Powercor

**Response to Regulatory
Impact Statement
Bushfire Mitigation
Regulations Amendment**

30 December 2015

Figure 2.1 Scenario of safety risks to be considered for different operating modes of a REFCL

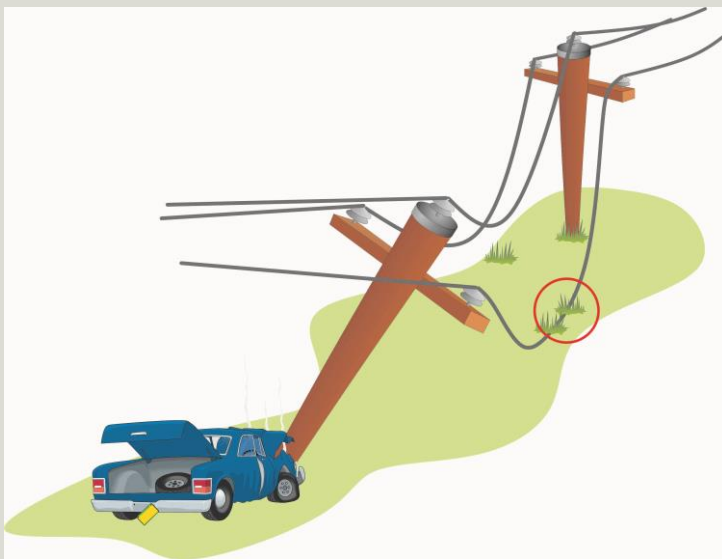
Public safety issues with the operation of the REFCL in extended compensation modes have not been discussed in the RIS. Extended compensation following the detection of a fault would involve the REFCL applying compensation and increasing voltages on the remaining healthy conductors for an extended period of time (e.g. eight hours). Customers would remain on-supply while the fault condition exists and the REFCL applies compensation.

Take for example a situation where a pole is hit by a car and comes down, such that one phase is in contact with the ground at zero potential, and the remaining two phases are closer to the ground but remain energised. The potential for a member of the public to contact these two live conductors is substantially increased.

We understand that this situation has occurred on networks with REFCLs installed and that there has been a potential safety risk during such events.

Given the box above, we note that safety risks of REFCLs are still being considered.

Figure 3.1 Target Area 7 Ballarat – Creswick, area identified for replacement

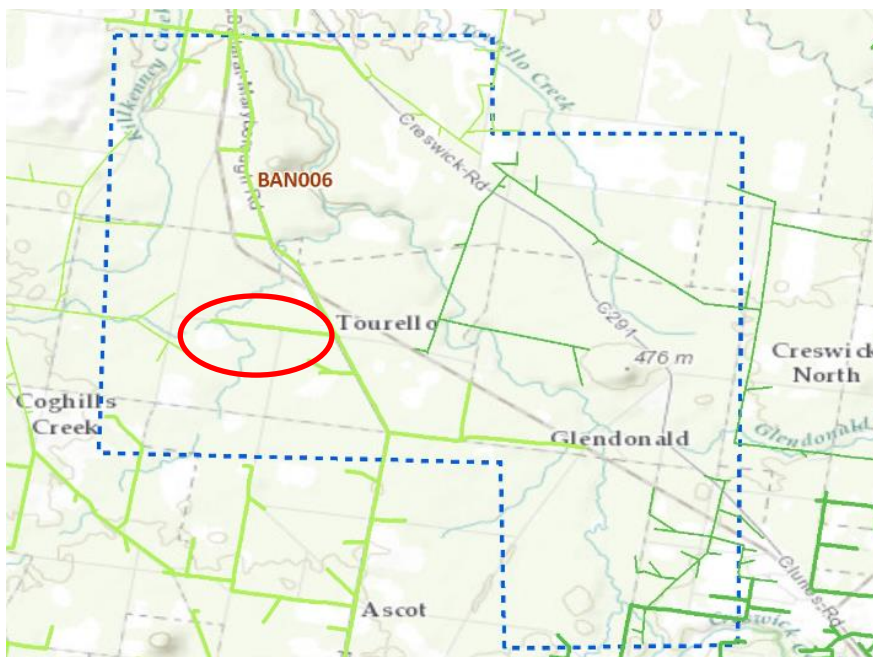
In reference to Target Area 7 Ballarat – Creswick, if the section circled in figure 3.1 below is identified in accordance with asset management policy as requiring replacement due to conductor condition and meets the definition of "wholly or substantially replaced" as defined in the draft Regulations, then it is unclear on what portion of the electric line is required to be replaced within the declared area.

Figure 3.2 Target Area 7 Ballarat – Creswick, replacement of spur

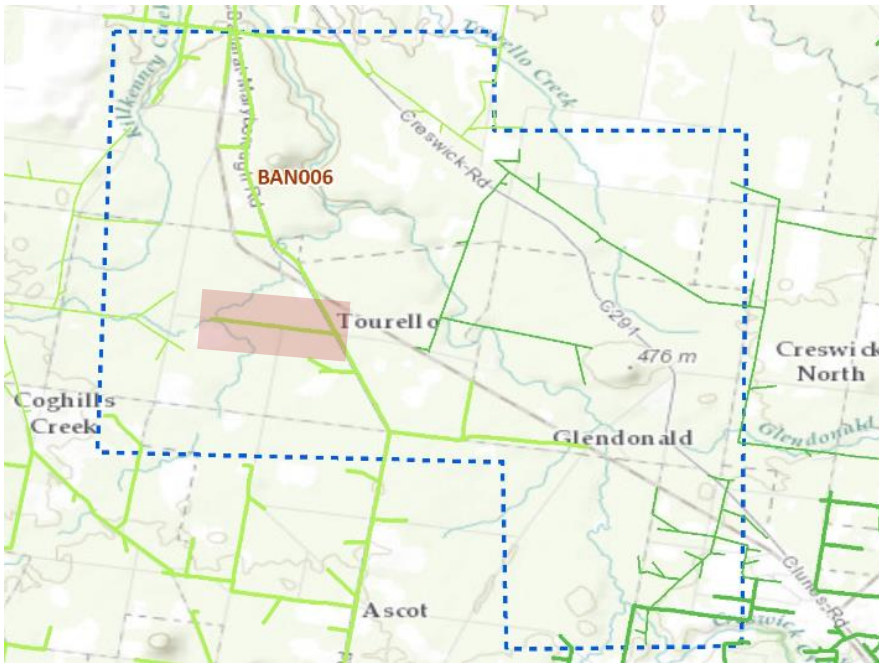
First, the replacement could be assumed to solely relate to the identified spur, as shown in the red highlight in the figure 3.2 below.

Figure 3.3 Target Area 7 Ballarat – Creswick, replacement of spur and backbone feeder

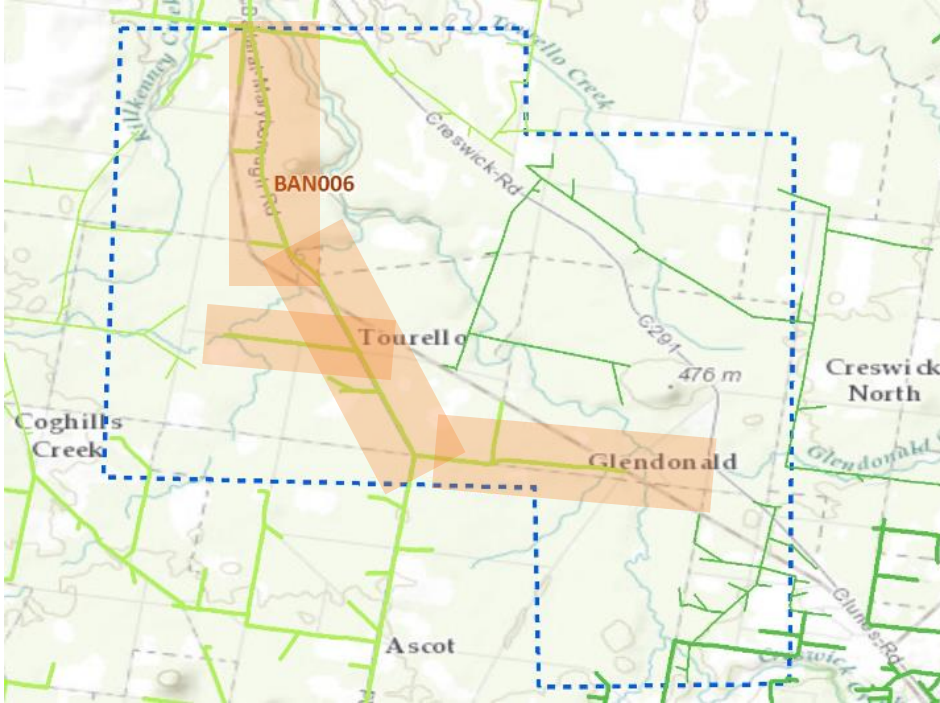
Alternatively the regulation could be interpreted as replacement of the spur and backbone of the BAN006 feeder within the declared area, as shown in the orange highlight in the figure 3.3 below.

Figure 3.4 Target Area 7 Ballarat – Creswick, replacement of all feeders in the declared area

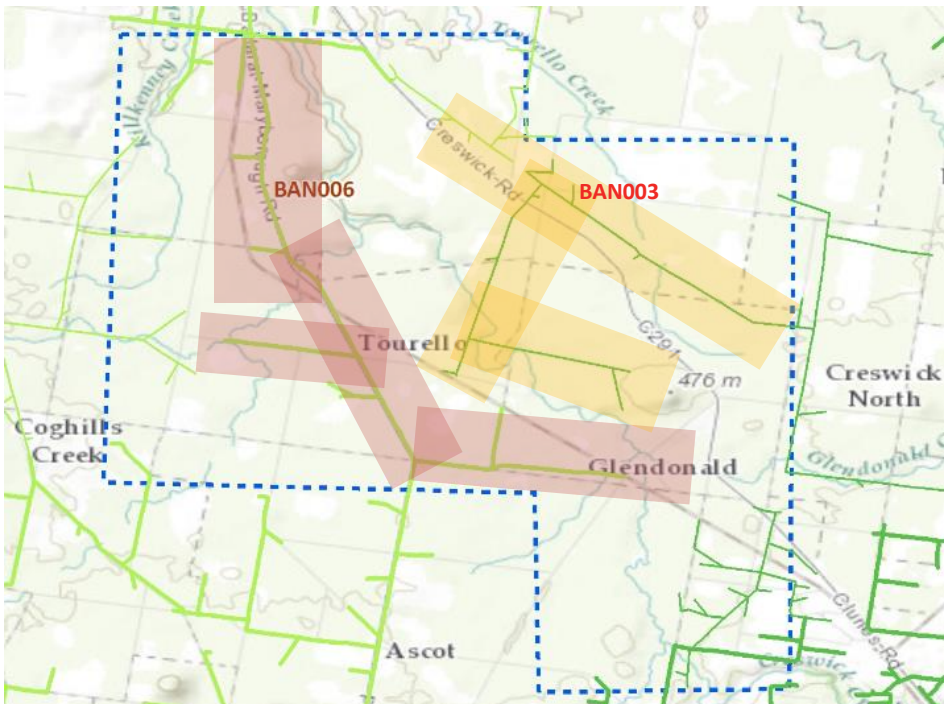
A further interpretation could be replacement of all lines within the electric line construction declared area as shown in the red and yellow highlights in figure 3.4 below
